LAFAYETTE PARISH PLANNING COMMISSION STAFF REPORT

SUBJECT: Preliminary Plat Approval

Partition of Tract 4B-1 Benton Ray Hebert creating Tracts 4B-1-A &

4B-1-B 2024-16-PC

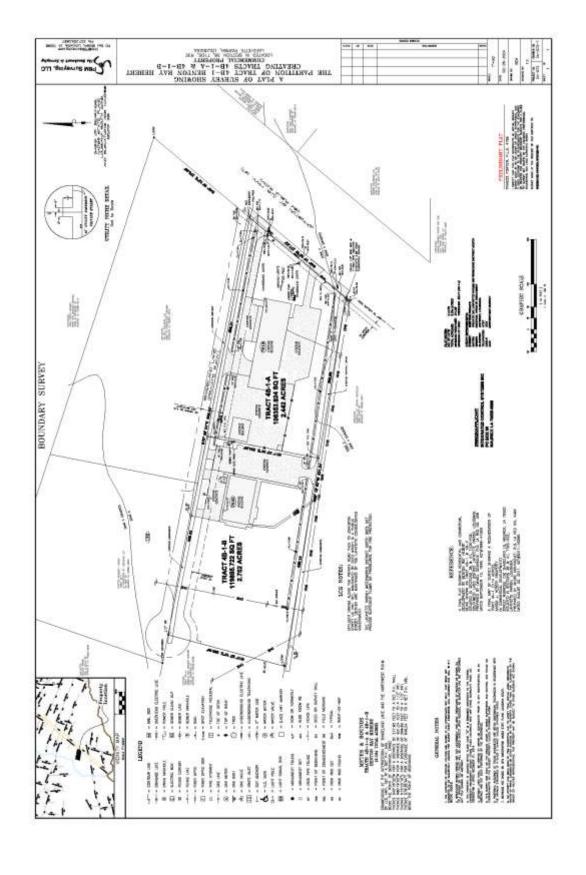
Comments: Address for Tract 4B-1-B to be determined prior to final plat approval
